# Groundwater Transfer Review Summary Form

Transfer/PA # T- 14859

Application: T-14859

Applicant Name: MCP Perm, LLC

### Application T-14859 MCP Perm LLC T1S, R2W, Section 31

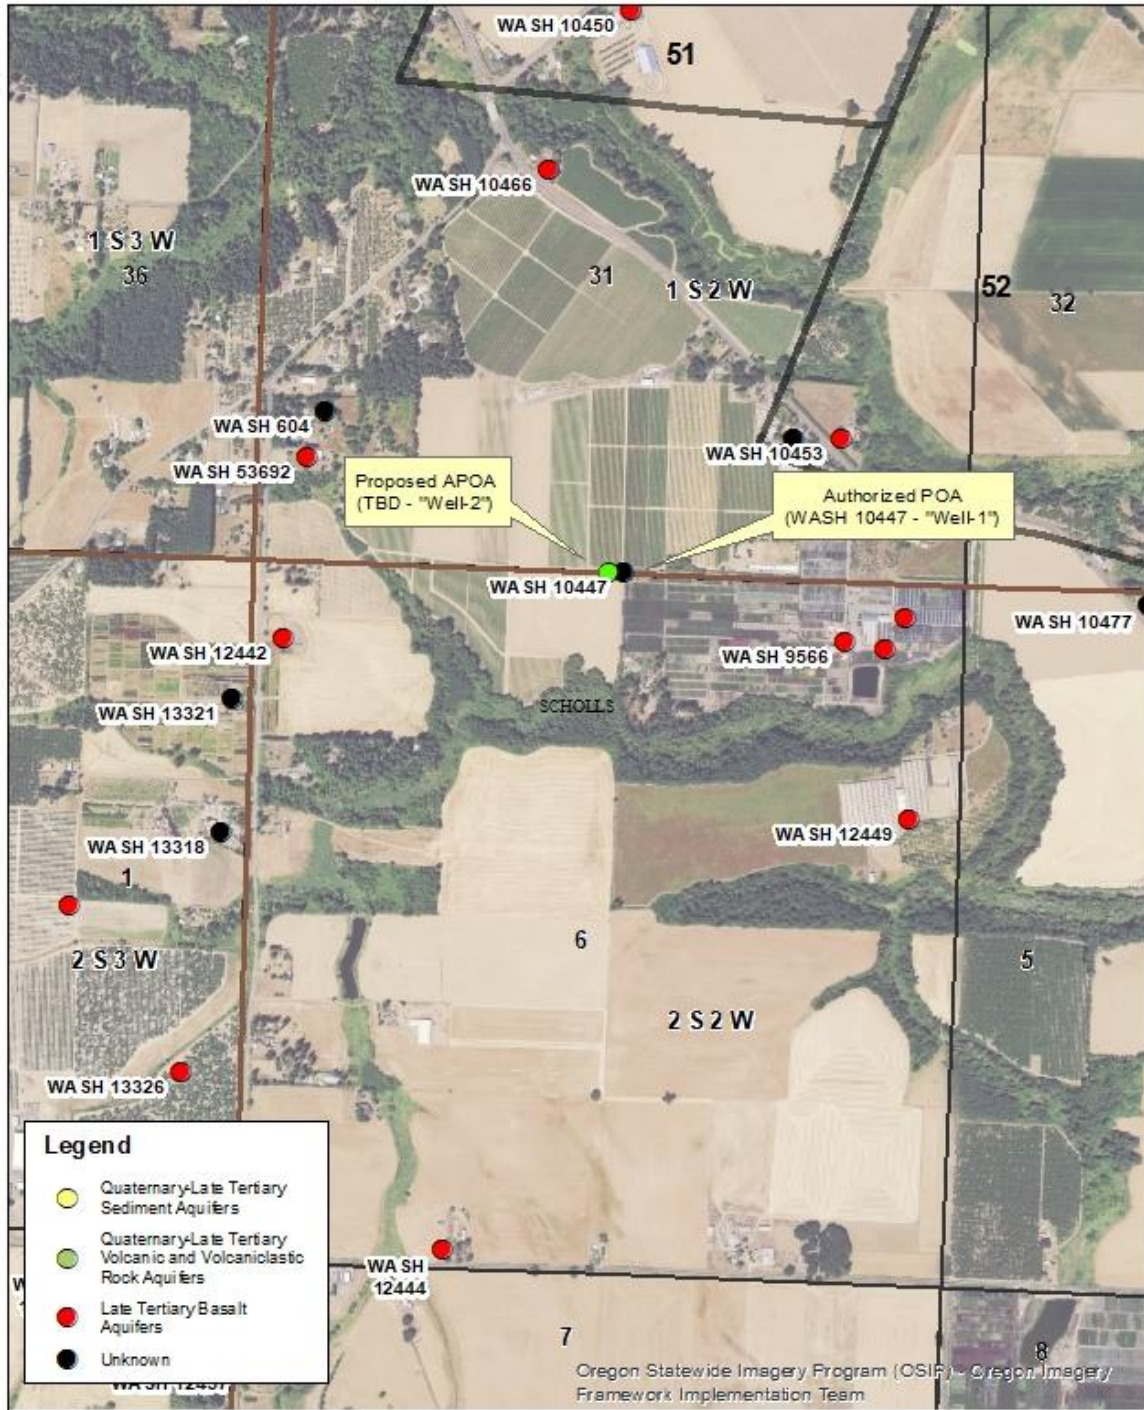
This transfer proposes a new POA ("Well-2", to be drilled) to replace the existing authorized POA WASH 10447.

2. Will the proposed POA develop the same aquifer (source) as the existing authorized POA?
Yes (checked) No
Comments: Existing WASH 10447 is 302 feet deep, cased and sealed to 165 ft bls, and obtains groundwater from water-bearing portions of the Columbia River Basalt Group (CRBG) aquifer system (Conlon and others, 2005; Woodward and others, 1998). Proposed "Well-2" is planned to be located within ~50 feet of WASH 10447, with a planned total depth of ~320 ft bls and sealed to ~200 ft bls; thus the proposed POA will develop the same aquifer source as the existing authorized POA.

5. a) Will this proposed change, at its maximum allowed rate of use, likely result in an increase in interference with **another ground water right**?  
 Yes  No Comments: The proposed replacement POA ("Well-2") is planned to be located very near to the existing authorized POA WASH 10447, and will also be constructed similarly. Thus there should be no changes in interference with any other groundwater rights.
